Director's Report

Project Name: Edendale

Description: Final Site Plan Approval

RE: Edendale Crossing- Final Site Plan Review – 1st Review

SCALE 1" = 30'
SHEET 4 OF 19
KE 2025.010

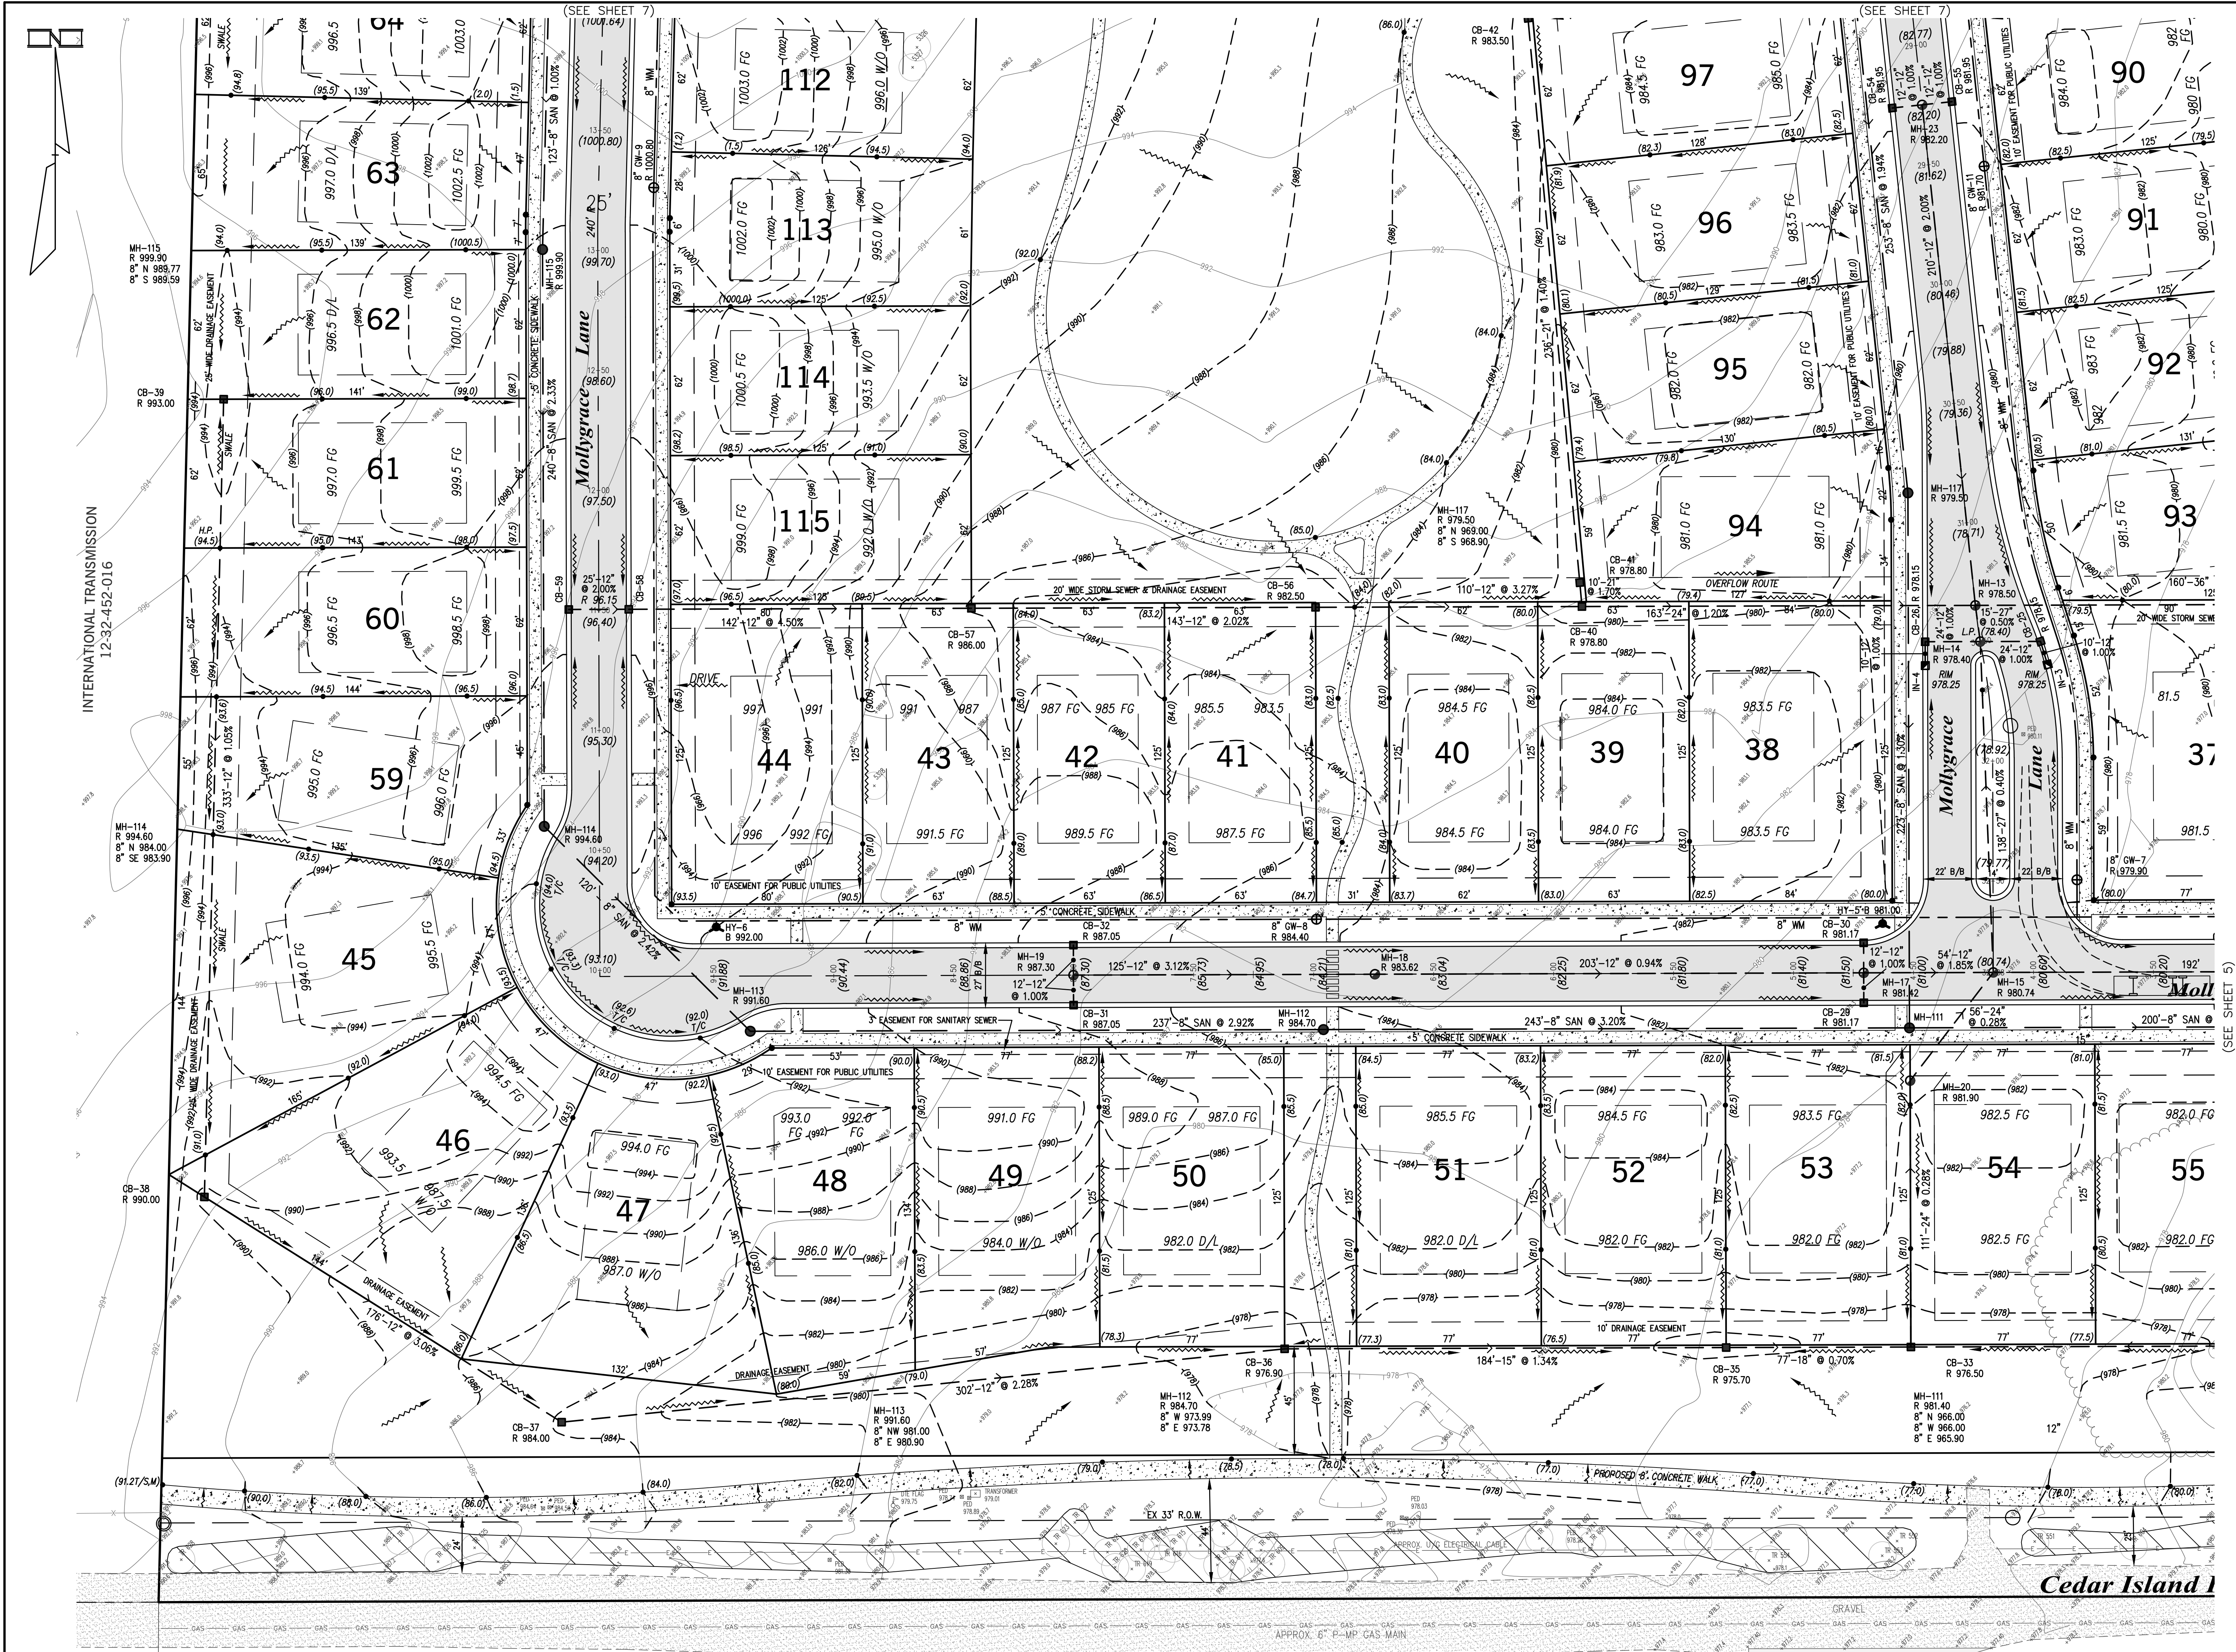
5. *Sheet 4- the previous submittal showed proposed contours in the area north of units 19-24. The current submittal does not show grading in this area; however the proposed grades seem to indicate that additional grading will be necessary with cuts of up to 10 feet. Please clarify as this will impact the disturbance area and the number of existing trees that can remain. **Comment addressed. The proposed grading and the previously proposed contours are now shown.***

SCALE	1" = 30'
SHEET	8 OF 19
KE	2025.010

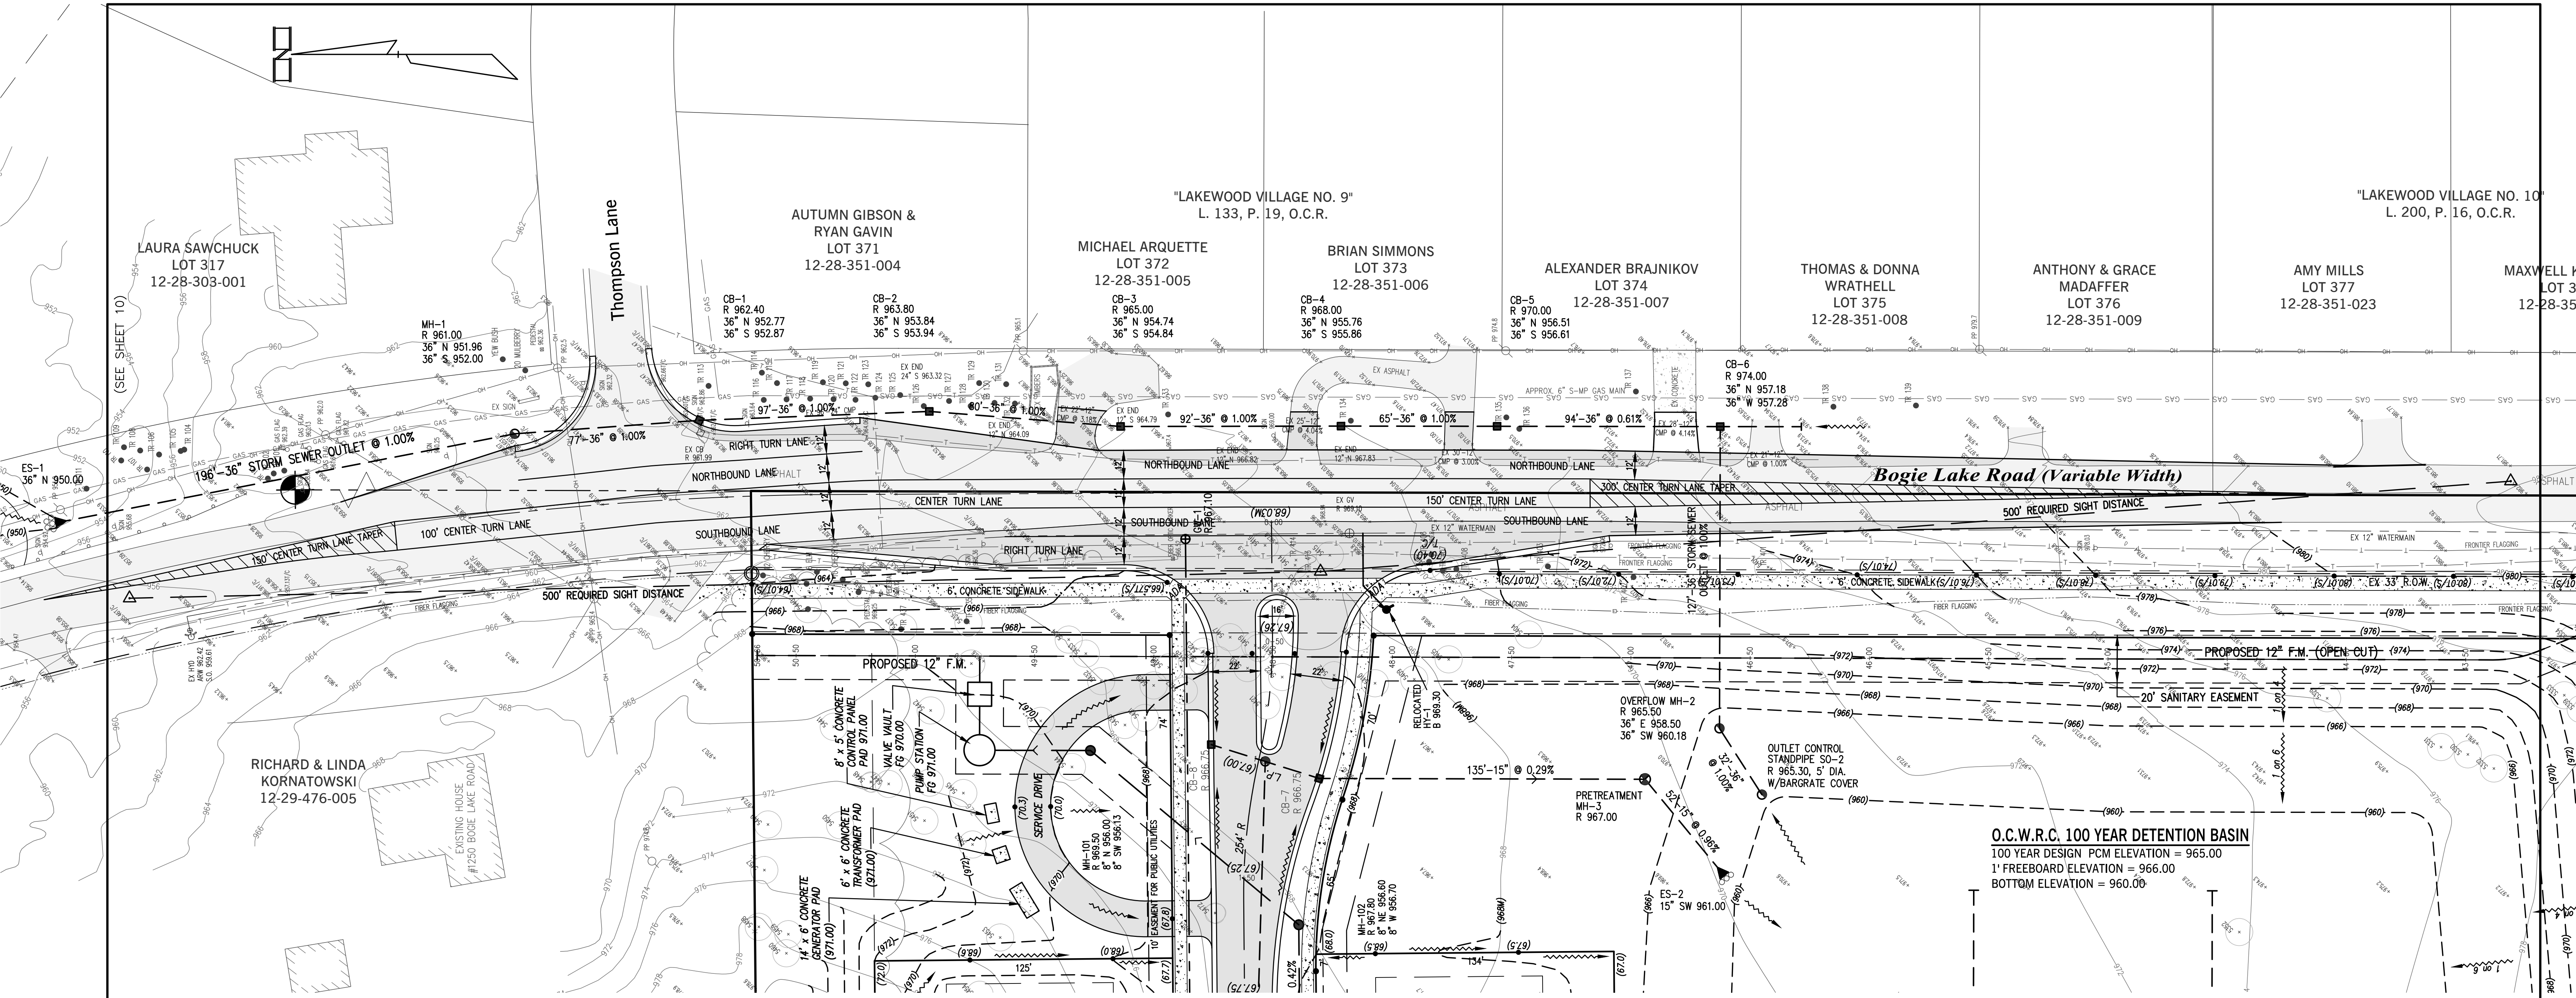
1. Sheet 8- It appears the discharge from the detention pond will flow across Parcel #12-28-303-001 which may require a storm drainage easement unless the storm sewer can be extended to a point there is no conflict. Comment addressed. A ditch that will route where the drainage to Thompson Lake goes is now proposed within the existing road ROW. **Comment remains as a notation.**

2. Sheet 8- The proposed storm sewer layout along Bogie Lake Road will need to be **clarified at the time of ~~Final Site Plan~~/Final Engineering Plan** to work with existing stormwater features, site drainage, and utility poles etc. **Comment remains as a notation.**

SCALE N/A
SHEET 11 OF 19
KE 2025.010

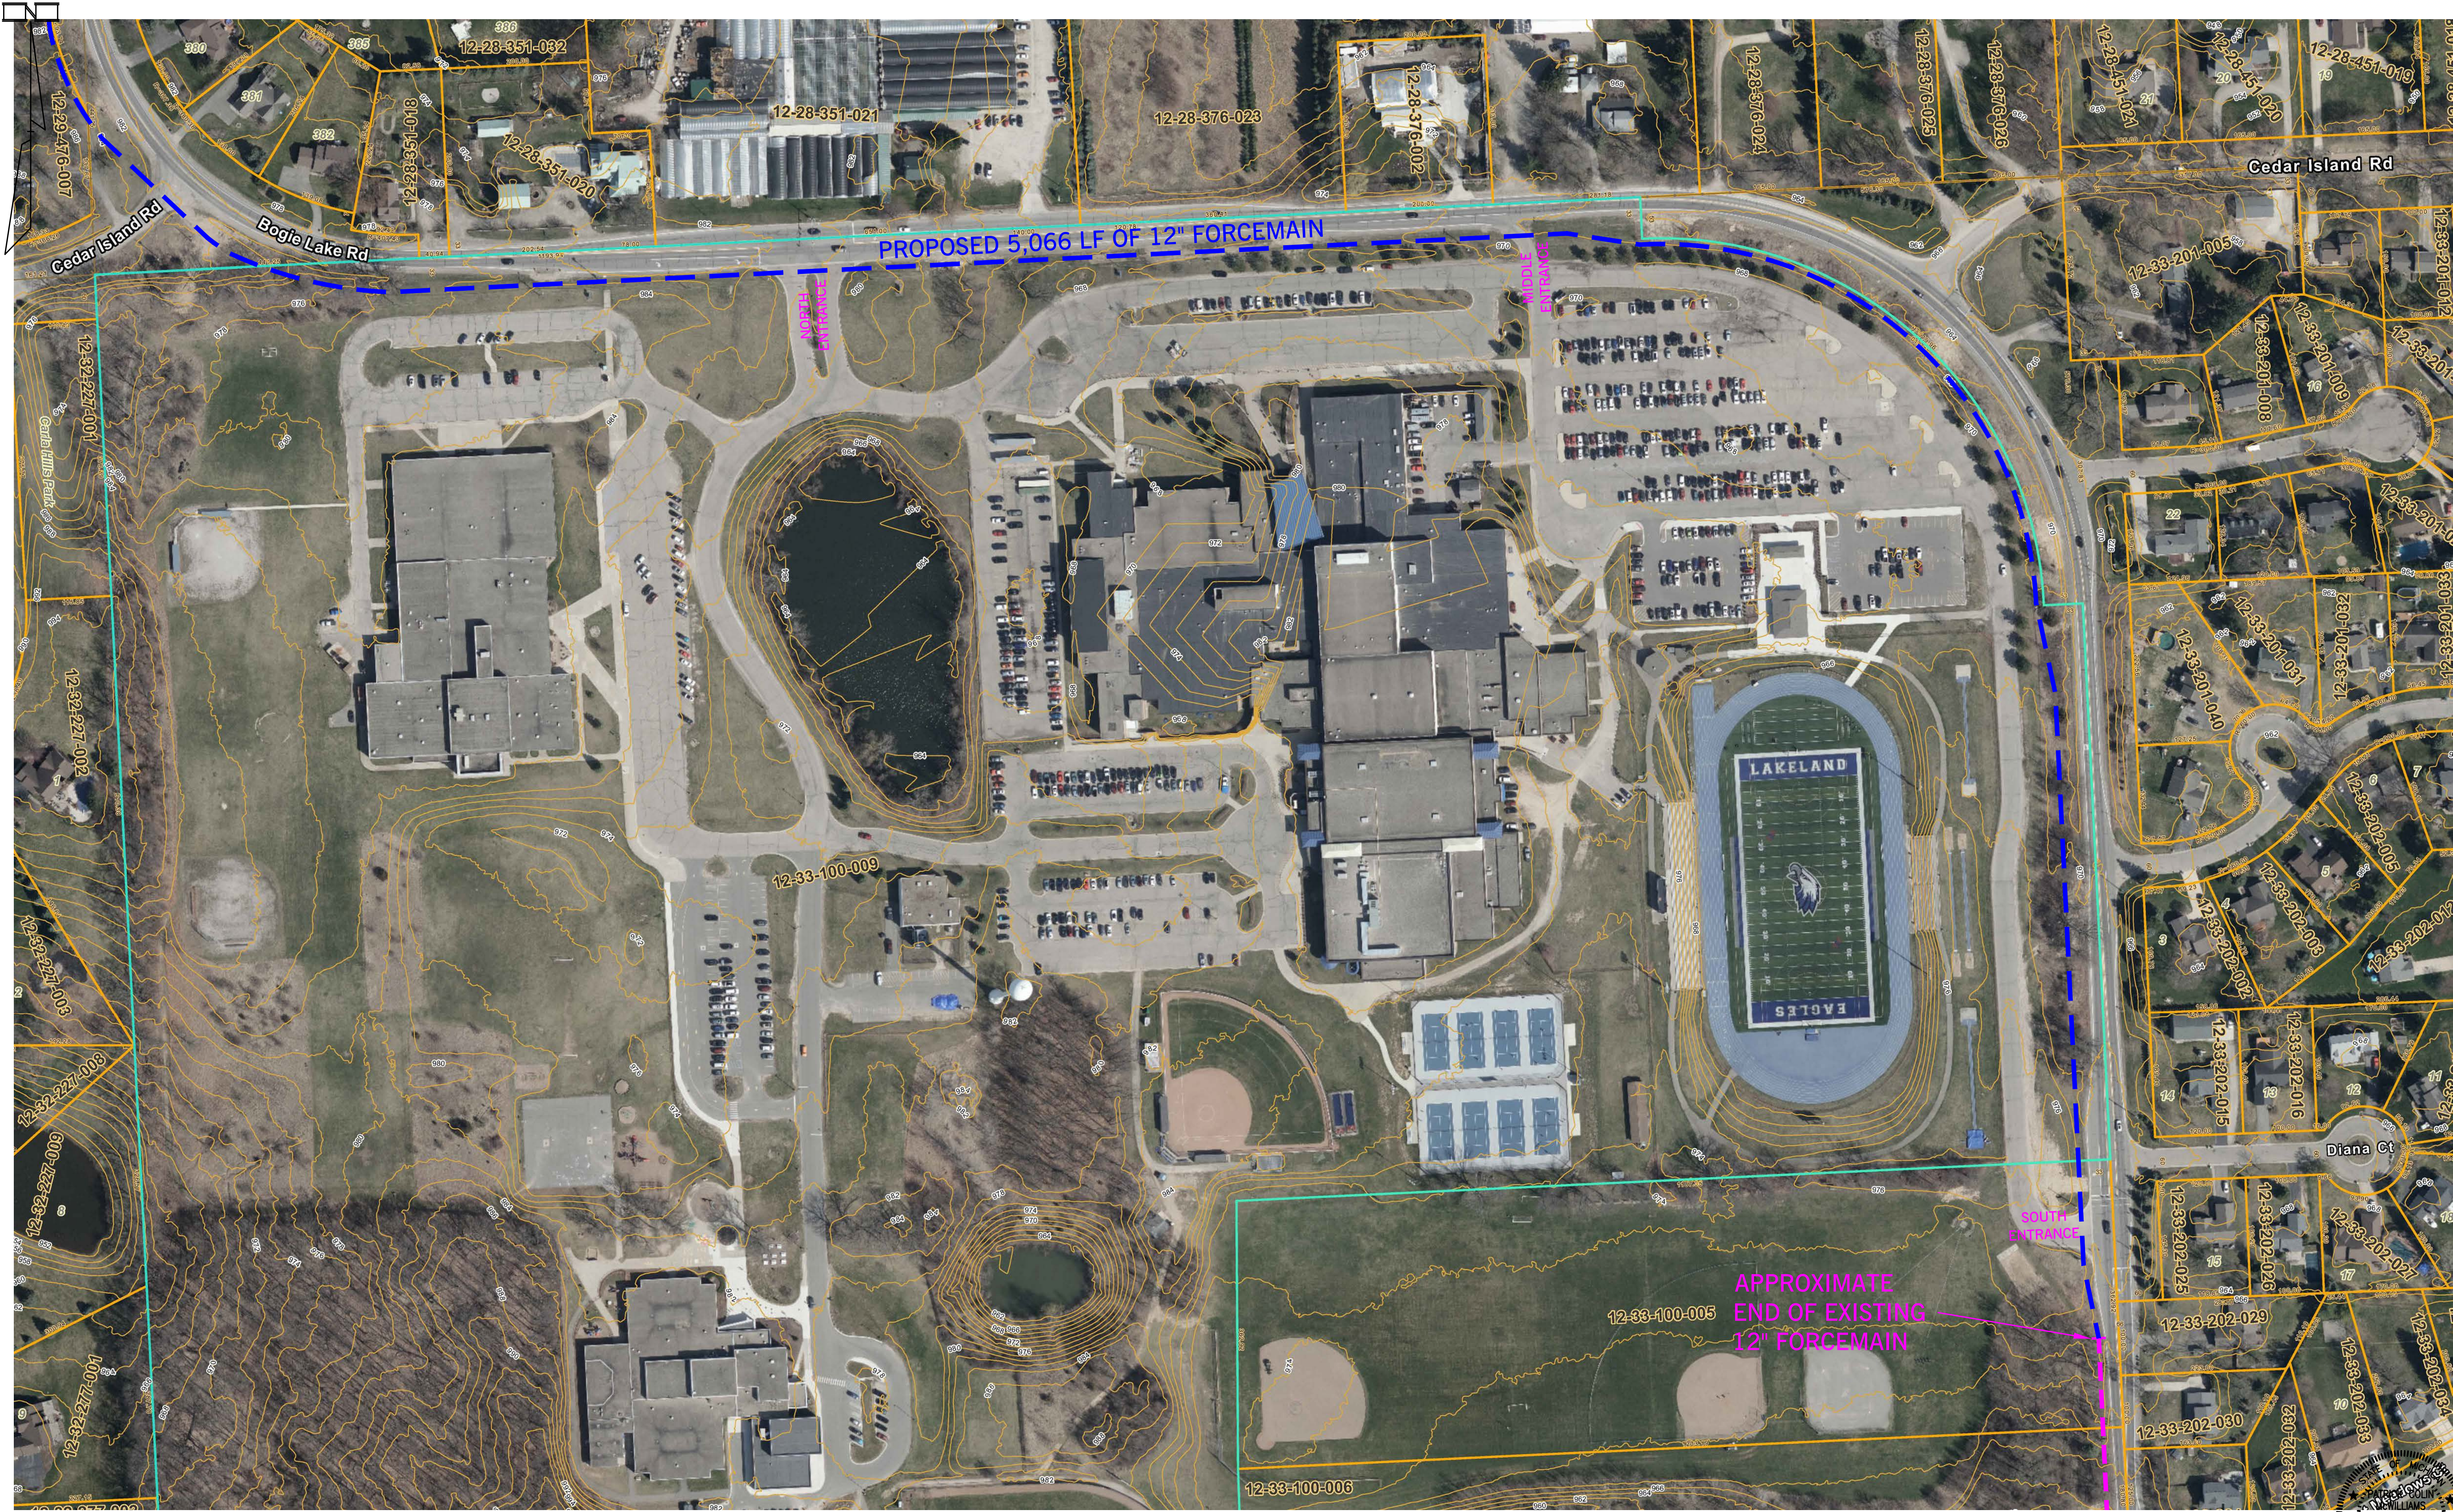
3. There are several comments/questions we have regarding the Detention Basin Calculations and Details Sheet 16. We have attached a red lined copy of the sheet for the design engineer's use. Comment partially addressed, but sufficient for this level of review. Please provide the T_t numbers in the 100 Year Basin Calculations. See attached plan sheet for a few remaining questions that can be answered with the FSP/FEP submittals. **Comment remains partially addressed but is sufficient for FSP level of review. Please see red-lined plan sheet of stormwater management calculations as there are still remaining items within the calculations that will require revision. These calculations shall be required to be addressed on the FEP.**

1. Sheet 11- Please see marked up calculations for revisions that shall be required.
2. We note that the location of the proposed sanitary pump station has changed from the Township Board approved Preliminary Site Plan. We consider the revised orientation to be an improvement compared to what was previously indicated so we do not take issue with this item but wanted to note the change.

Stormwater calculations:	100-year basin calculations have been revised and are provided on Sheet 11
